**Safety Evaluation Report (Revised)**  
for the Dewey-Burdock Project  
Fall River and Custer Counties,  
South Dakota

**Materials License No. SUA-1600**

Docket No. 40-9075  
Powertech (USA) Inc.

**April 2014**

Figure 1. Comparison of the Reported Drawdown and Drawdown from the modeling Software

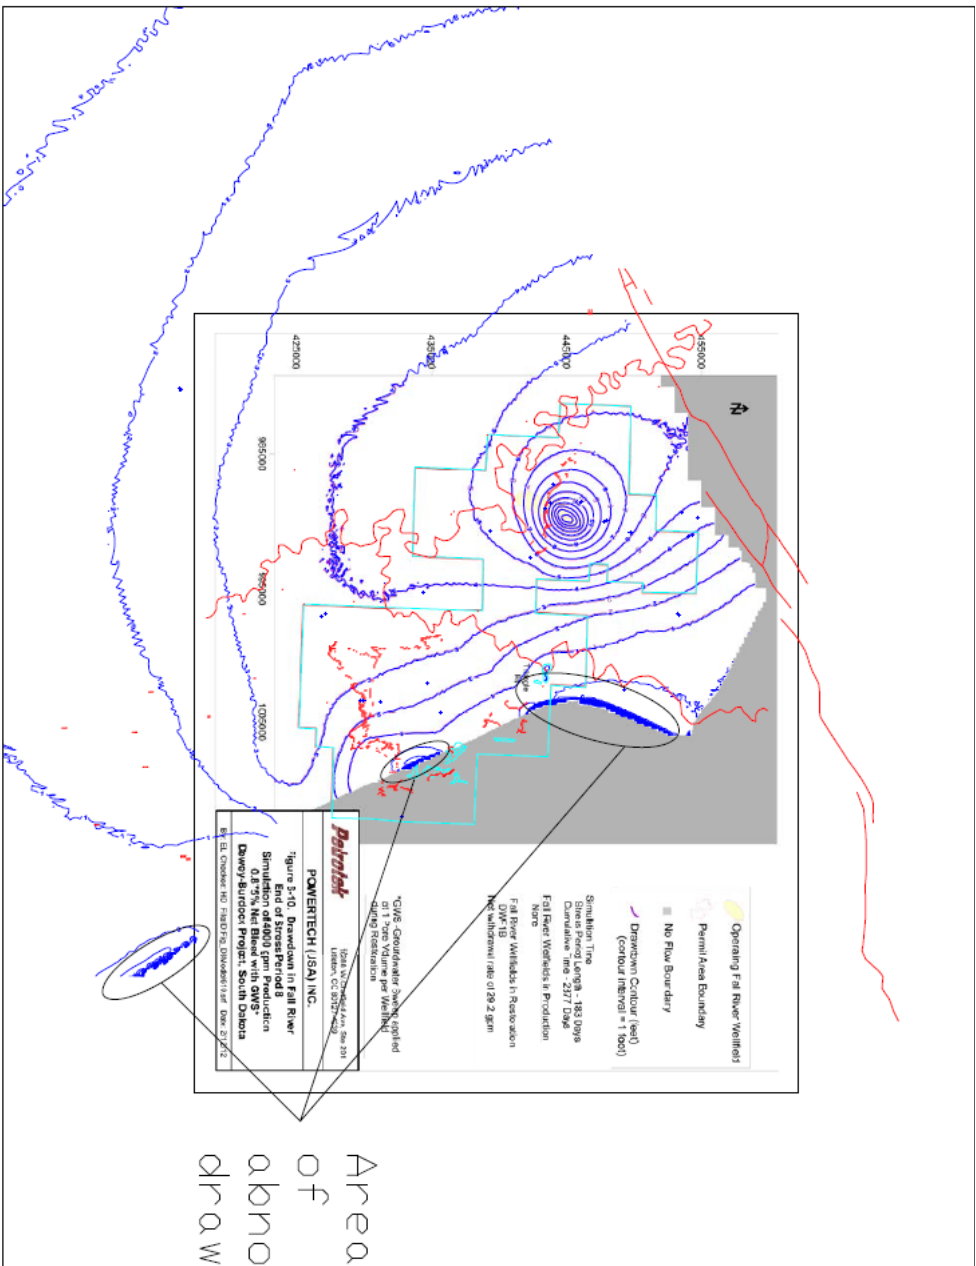
Staff reviewed the model geometry, hydraulic properties and parameters and locations of the boundaries. Several minor discrepancies were noted between the electronic files and the report (Table 1). In general, the discrepancies represent minor errors and are common for complex models. Most of the discrepancies would not appreciably impact the model predictions; however, staff was concerned about the abnormal drawdown adjacent to the GHB conditions (Figure 1). The abnormal drawdown may be attributed to discrepancies noted in the recharge, storativity or GHBs (see Table 1), or, conflicts with the starting head file.<sup>1</sup>

Area  
 of  
 abnormal  
 drawdown

Staff corrected the model for discrepancies in recharge, storativity and GHBs, and established starting heads for the predictive simulation using the output from the steady-state calibration simulation. Correcting the model affected the predicted drawdowns in the Fall River Formation and Chilson Member, as shown in Figure 2 and Figure 3, respectively. The effect of the corrected model on the Fall River Formation model-predicted drawdown is to increase the drawdown by approximately 1 foot. The effect on the Chilson Member model-predicted drawdown is less than that for the Fall River Formation.
